METROPOLITAN GOVERNMENT OF NASHVILLE AND DAVIDSON COUNTY

STAFF RECOMMENDATION
1905 Fatherland Street
February 18, 2015

Application: New construction-addition
District: Lockeland Springs-East End Neighborhood Conservation Zoning Overlay
Council District: 06
Map and Parcel Number: 08314017100
Applicant: John Teselle, architect
Project Lead: Paul Hoffman, paul.hoffman@nashville.gov

<p>Description of Project: Construction of a rear addition to this contributing home.</p> <p>Recommendation Summary: Staff recommends approval with the conditions:</p> <ol style="list-style-type: none"> 1. Staff approve the final details, dimensions and materials of windows and doors prior to purchase and installation; and, 2. Staff approve the roof color and masonry color, dimensions and texture; 3. If HVAC and utilities are to be moved, that they be on the rear façade, or on a side façade beyond the midpoint of the house. <p>Meeting these conditions, Staff finds the project meets the design guidelines for the Lockeland Springs-East End Neighborhood Conservation Zoning Overlay.</p>	<p>Attachments A: Photographs B: Site Plan C: Elevations</p>
--	--

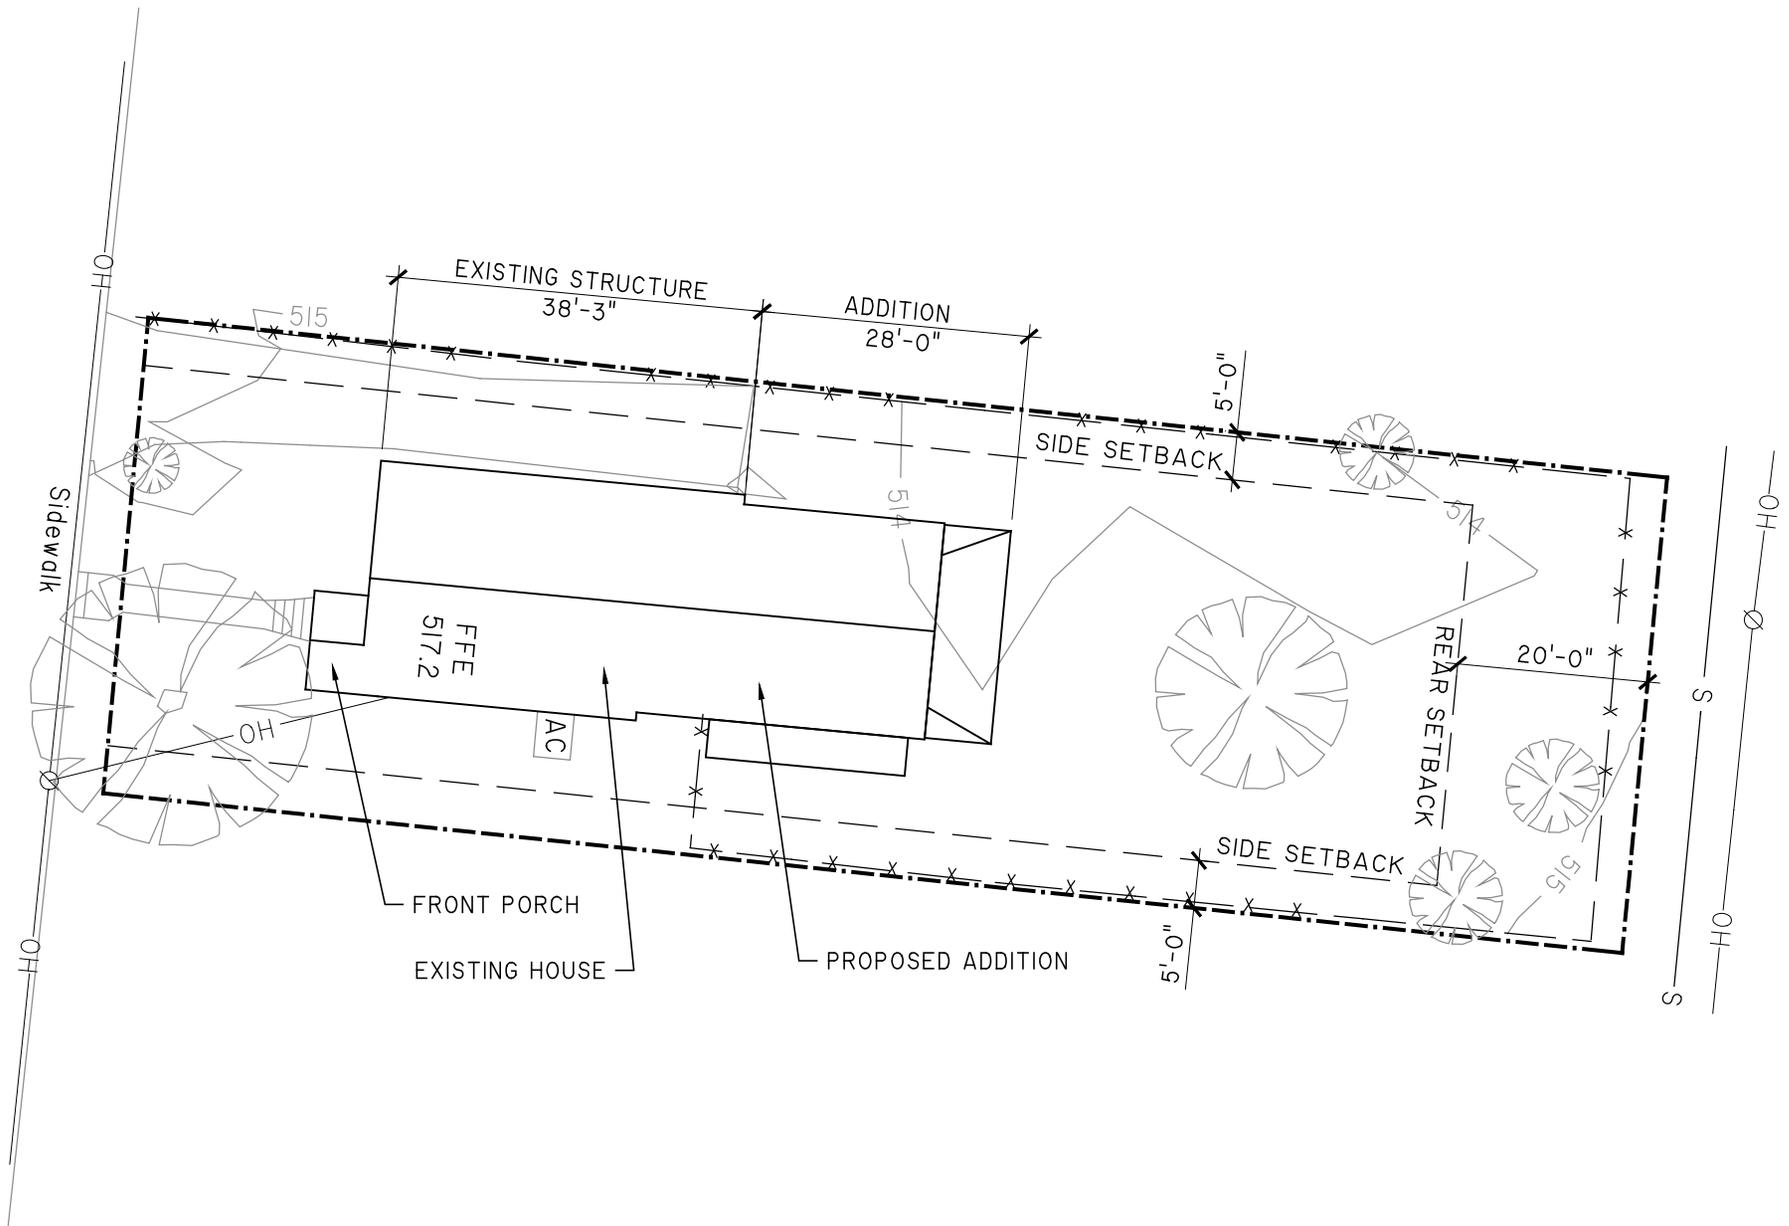
A twenty-one foot (21') section of the addition's right side is proposed to be wider than the side wall of the house by three feet (3') (see Figure 3). The design guidelines state that an addition may go wider than the existing house if the house is thirty feet (30') or less in width. This house is twenty-five feet (25') wide. Given the especially narrow house and the fact that the extension still meets the bulk standards, staff finds that the width of the addition and the height and scale of the addition would be compatible with surrounding buildings and would meet guidelines II.B.1 and II.B.2.

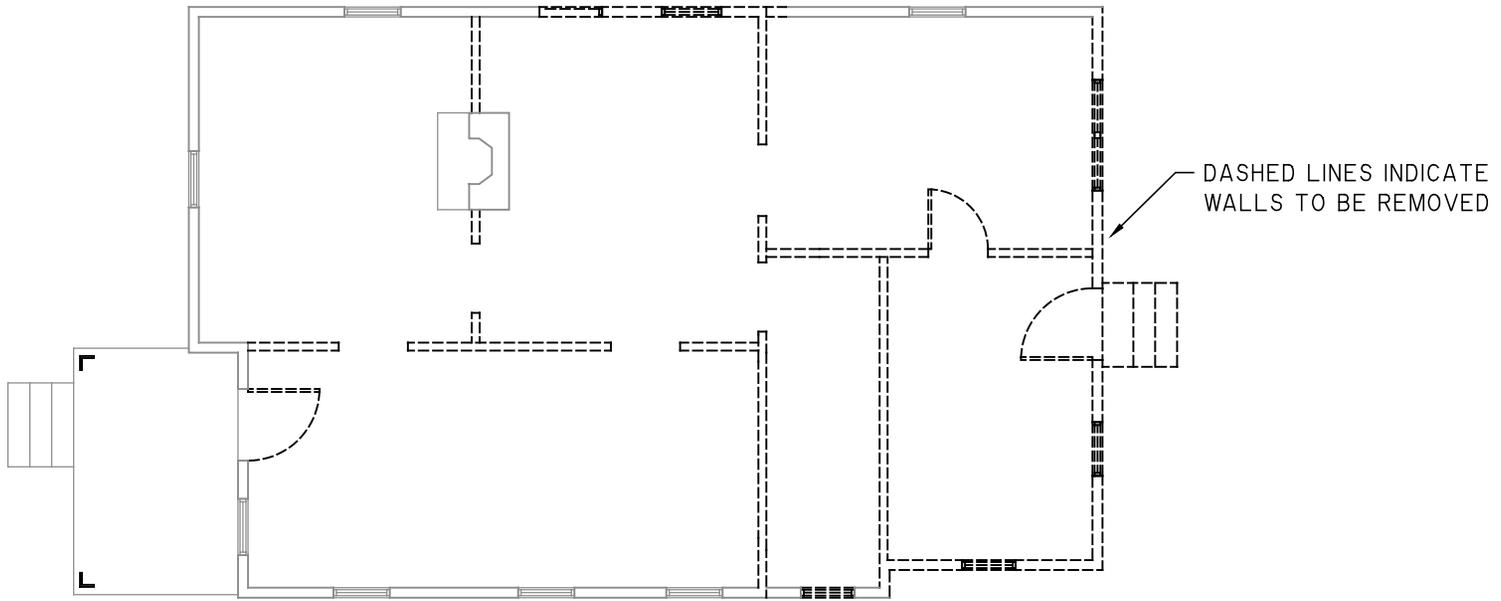
Appurtenances & Utilities: The project's site plan does not indicate changes to the site's appurtenances or utilities. If HVAC is to be moved, Staff requests that it be located at the rear, or on a side façade beyond the midpoint of the house. The application meets section II.B.9.

1. Staff approve the final details, dimensions and materials of windows and doors prior to purchase and installation; and,
2. Staff approve the roof color and masonry color, dimensions and texture
3. If HVAC and utilities are to be moved, that they be on the rear façade, or on a side façade beyond the midpoint of the house.

DEMOLITION FLOOR PLAN

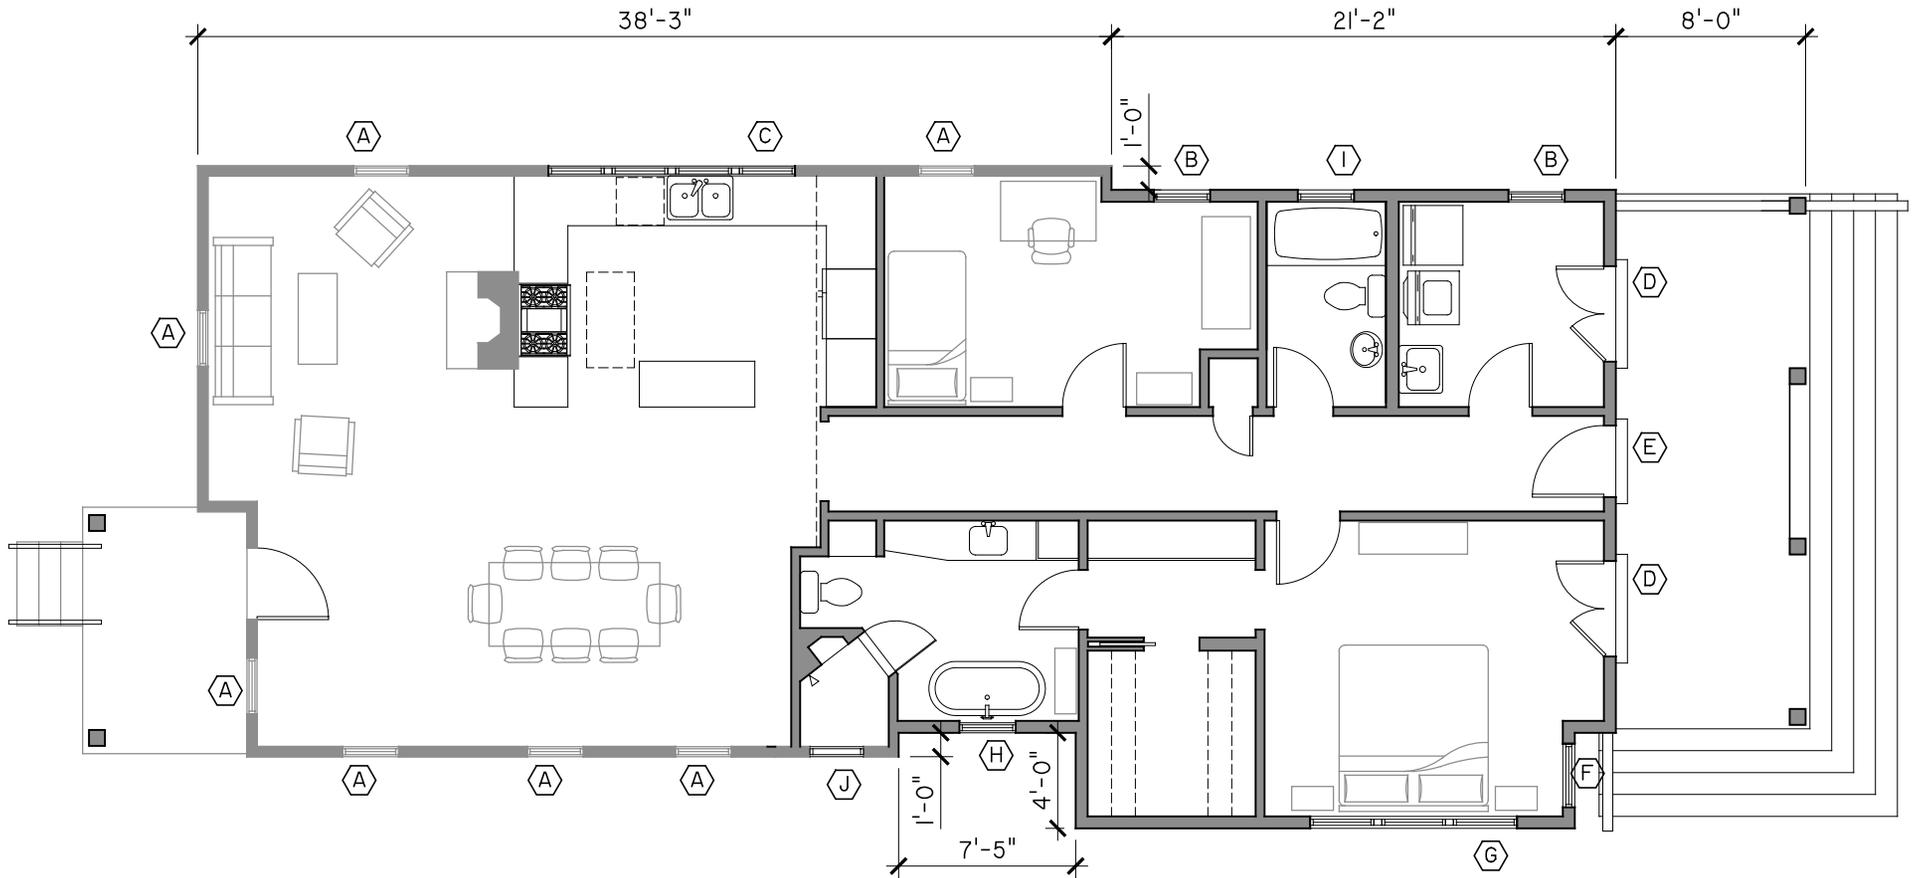
Demolition: The project calls for demolition of the existing rear additions, replacing the roof structure, and changing two windows on the west side to four windows. The additions are not original to the house and were built after 1957, according to the Sanborn map from that year. The window openings being replaced are at the approximate midpoint of the house, and the visual impact of the change will be minimal. The owners intend to keep as much of the existing wood siding and windows as possible. Some replacement of siding, windows or doors may be required. Removal or replacement of these portions of the house will not be detrimental to the historical or architectural integrity of the building. The partial demolition requested meets section IV.B.2 for appropriate demolition and does not meet section IV.B.1 for inappropriate demolition.

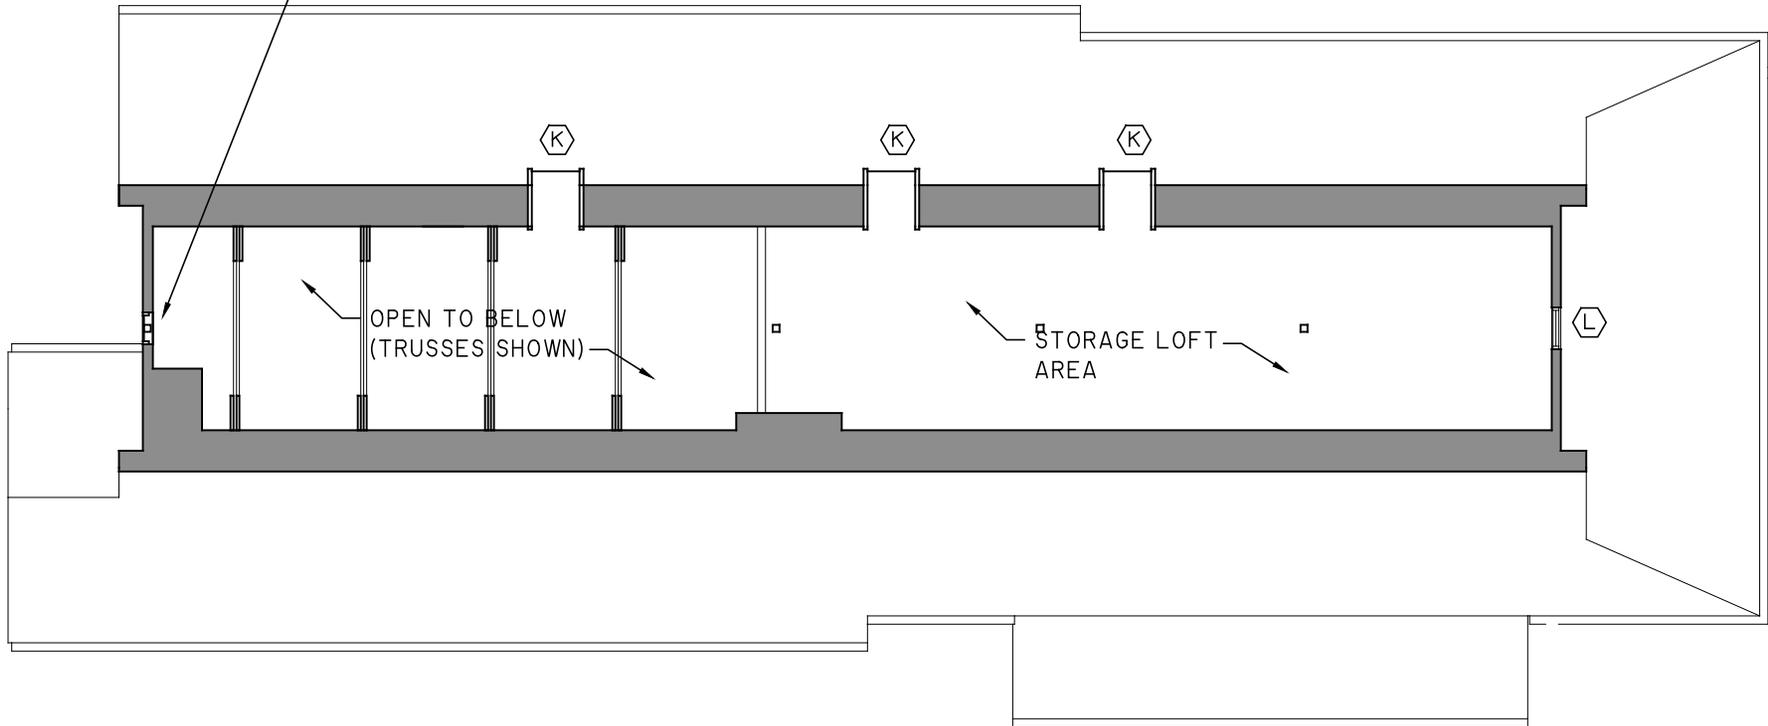
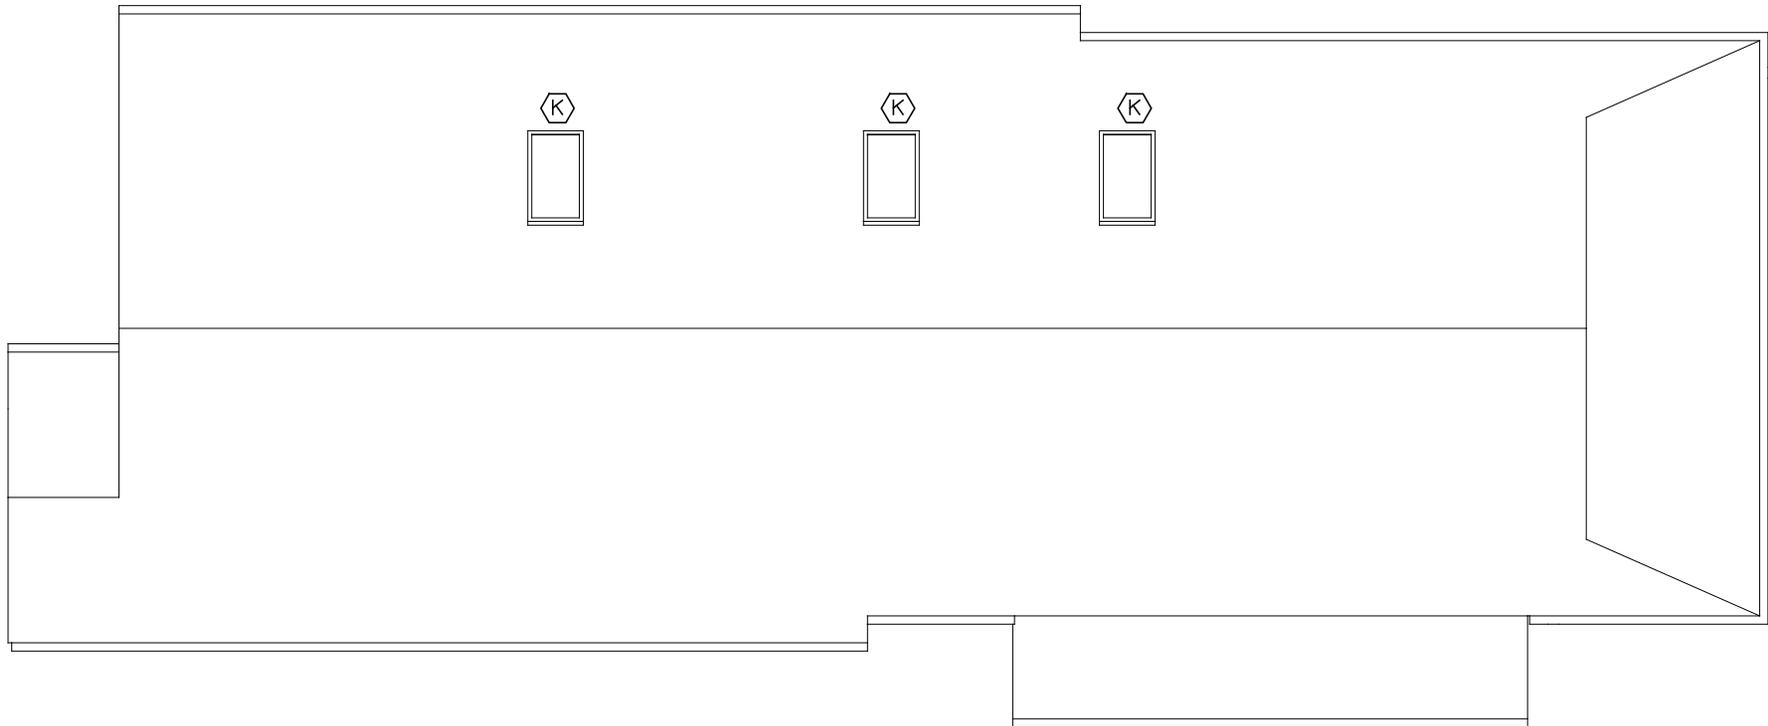
STRUCTURAL POST DIRECTLY BELOW RIDGE BEAM IS CONCEALED IN FALSE LOUVER WINDOW AT FRONT OF HOUSE. EXISTING OPENING TO BE CONVERTED TO FALSE LOUVER WITH USING RIDGED PANEL.

NEW WOOD SIDING
TO MATCH
EXISTING

COLUMNS TO MATCH FRONT
PORCH

REBUILT CHIMNEY TO
REPLACE MISSING ORIGINAL
CHIMNEY
